Nov. 26<sup>th</sup>, 2020

## MCM\*/MCKM\*/MCBMI/MGT\*/MSLL-Ø 16~Ø 40 Adjustable Cushion Type Cylinders Change Port Hole Notification

Before (For example: MCMB-Ø 25-A series)	After (For example: MCMB-Ø 25-A series)
Smaller port orifice	Full port orifice

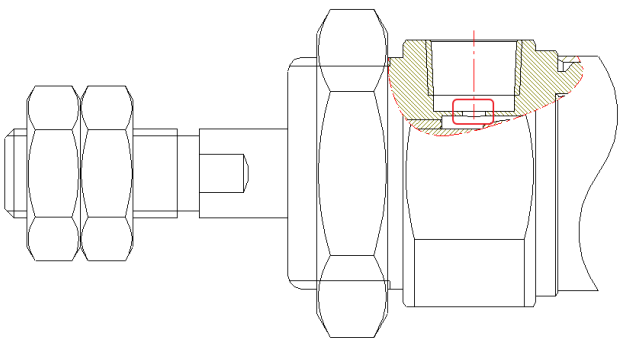
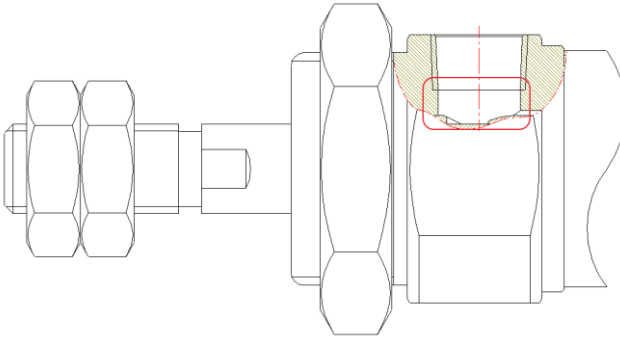
Change design of port hole to optimize product performance.
